- 1. USED TO REMOVE & REPLACE BEARING LOCK NUT #SL6IN-8F FROM ASSEMBLED TRANSMISSION FOR FIELD SERVICE OF OIL SEAL #369A55199 AND SHROUD MOUNT #369A5104.
- 2. REF. MD T/N: 369A9966.

BARREL WRENCH SET

RBA9966

WRENCH, NUT

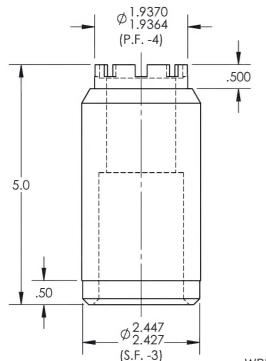
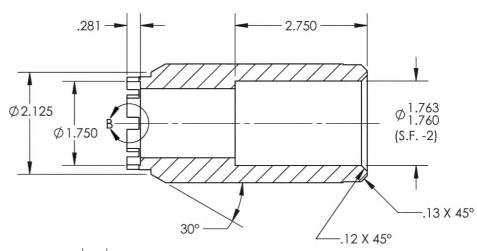
REVISIONS								
REV	ECR	DESCRIPTION	DATE	INITIAL	APPROVED				
1		CHANGED MATERIAL FROM 4140 OR 41L40 TO 4140 Q&T.	2/27/2009	WP	DW				
3	17-0056	-1 CH'D MAT'L WAS 4140 Q&T IS 4140/4142. CH'D DIM WAS Ø1.937 PF -4 IS Ø1.9364-1.9370 (P.F4). ADDED DIMS .50 Ø2.427-2.447 (S.F3). ADDED NOTE RC 30-35 HEAT TREAT BEFORE MACHINING.	6/16/2017	DPD	JAG

NOTE: RC 30-35 HEAT TREAT BEFORE MACHINING.

WRENCH SPLINE

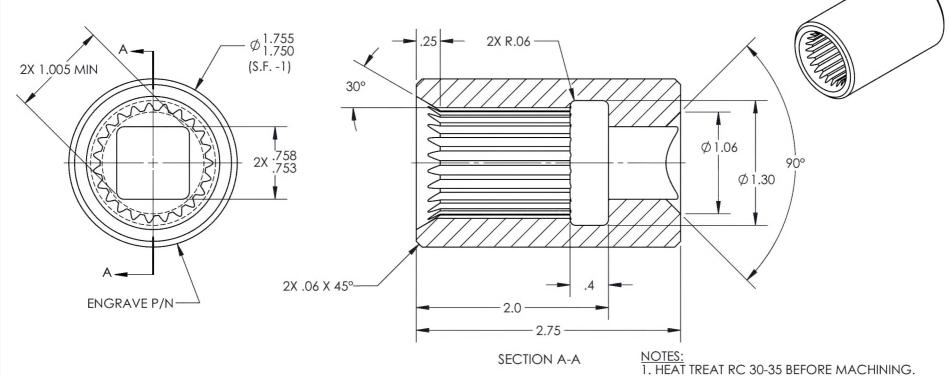
REVISIONS REVISIONS							
REV	ECR	DATE	INITIAL	APPROVED			
1		-2 CH'D MATERAIAL FROM 4140 OR 41L40 TO 4140 Q&T.	2/27/2009	WP	DW		
3	17-0056	-2 CH'D DIM WAS .75 \$Q. IS 2X .758/.753. ADDED DIMS 2X 1.005 MIN, Ø1.755/1.750 (S.F1), 90°. DELETED DIMS R1.0, Ø1.105-1.100. CH'D MAT'L WAS 4140 Q&T IS 4140/4142. ADDED HEAT TREAT RC 30-35 AFTER MACHINING. ADDED FINISH SPEC QMSI-6.2.2, B.O. REV D. ADDED TIMING NOTE.	6/15/2017	RJC	JAG

1. HEAT TREAT RC 30-35 BEFORE MACHINING
2 TIMING OF FEATURES NOT CRITICAL

SLEEVE

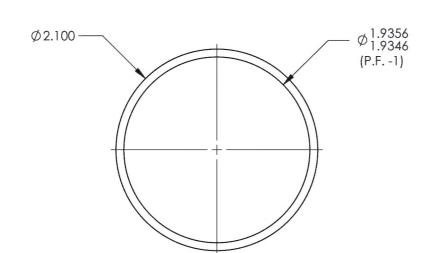
revisions								
REV	ECR	DESCRIPTION	DATE	INITIAL	APPROVED				
3	17-0056	-4 CH'D MAT'L FROM 1018 TO 1018/1020 CR. ADDED FINISH BLACK OXIDE QMSI-6.2.2, B.O. REV D. CH'D DIM WAS Ø1.937 P.F1 IS Ø1.9346-1.9356 (P.F1).	6/16/2017	DPD	JAG

WELDMENT, BARREL WRENCH

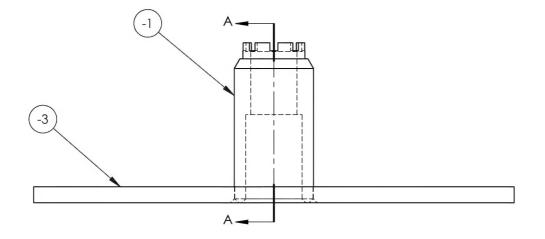
REVISIONS						
REV	ECR	DESCRIPTION	DATE	INITIAL	APPROVED		
3		-5 ADDED FINISH SPEC QMSI-6.2.2, B.O. REV D.	6/16/2017	DPD	JAG
